A47/A11 Thickthorn Junction

Scheme Number: TR010037

9.16 Request for a Non-Material Change to the Application

A47/A11 Thickthorn Junction
Development Consent Order 202[x]

Figure 2.1 – Change to the alignment of the A11-A47 Connector Road

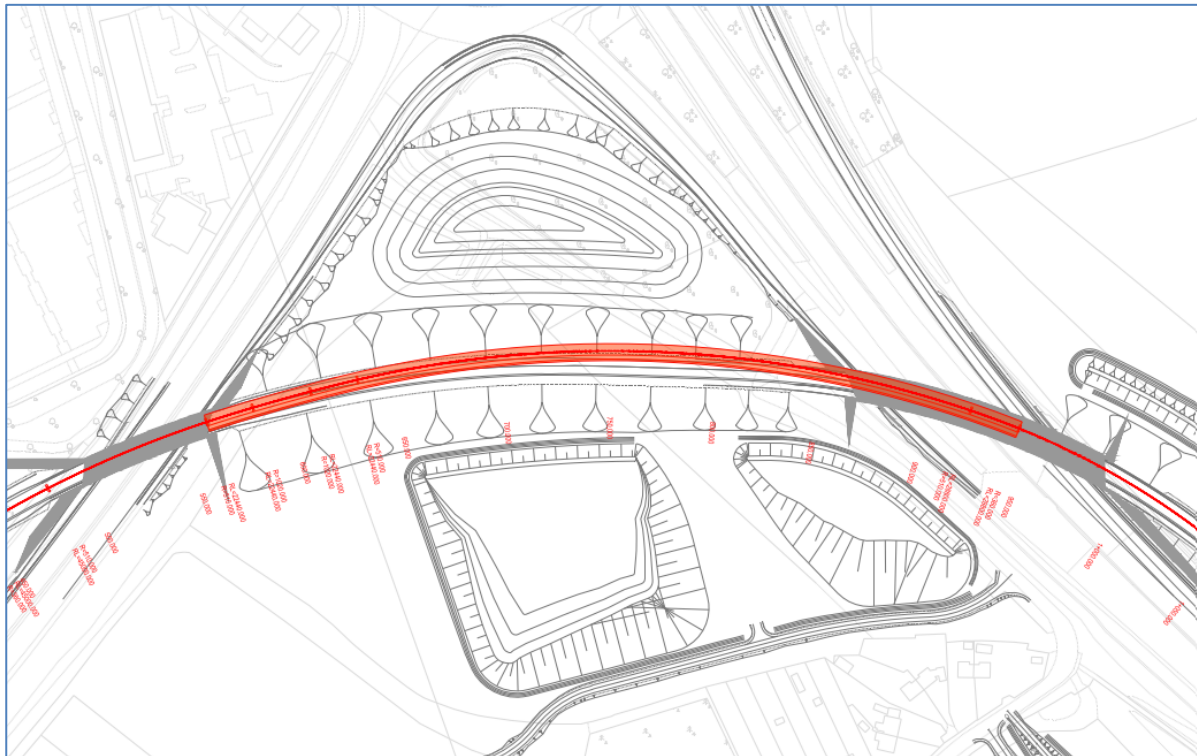
- 2.4.1 The alignment of the A11/A47 Connector Road has been amended to reduce the cross section of the Cantley Lane Underpass. This will reduce the requirements for construction materials and excavation of in situ material.
- 2.4.2 The horizontal curvature of the road has been amended so that at the apex of the curve the centreline of the road is approximately 7 metres to the north of the current centreline. This difference reduces to zero at the entrance to the Cantley Wood Underpass to the east, and at the exit from the Wards Wood underpass to the west as the proposed alignment ties back in with the current alignment.
- 2.4.3 Figure 2.1 shows a comparison between the existing alignment shown in grey and amended alignment shown in red. Amendments to the earthworks and bunding have been omitted from the figure for clarity.

2.4.4 The cross section of the road is unchanged, which means that there will be a corresponding shift in the position of cutting extents required for the connector road. The bunding north and south of the connector road has also been amended to reflect the change in the extents of the cutting. These changes are minor and hard to detect on the revised plans.

- 3.3.2 A reduction in the cross section of the Cantley Lane Underpass can be achieved by adjusting the horizontal alignment of the A11/A47 connector road between the Wards Wood Underpass (S02) and the Cantley Lane Underpass (S04) as shown on the General Arrangement Plans (**APP-005**). This will reduce the width of the offside verge required through the Cantley Lane Underpass to accommodate forward visibility widening. The maximum deviation from the current alignment is 7m horizontally to the north.
